Dixie-Narco

Service Bulletin #te: December 24, 1986

MODEL: DNCB CC Coke Venders

SUBJECT: Installation

Validator Mounting Plate

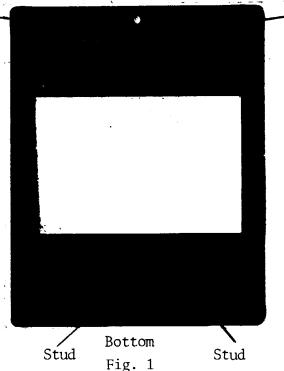
REASON: To provide parts which will enable Coca-Cola Bottlers to install

subject validator in the New INCB CC Coke Venders.

DO THIS: 1. Remove the Validator cover plate from the vender's Main Door, and keep the four (4) Keps Nuts.

2a. Install the Validator Mounting Plate (bottom down - Fig. 1) in the opening from which the Validator Cover Plate was removed.

b. Once inserted, install two (2) Keps Nuts (as spacers) on top studs and two (2) 5/16 Stand Off (as spacers) on the bottom studs.

3a. From the rear of the Main Door, align the nose piece of the Validator with the Validator opening, and push through.

b. Align Validator holes with Mounting Plate Studs and secure Validator with Keps Nuts.
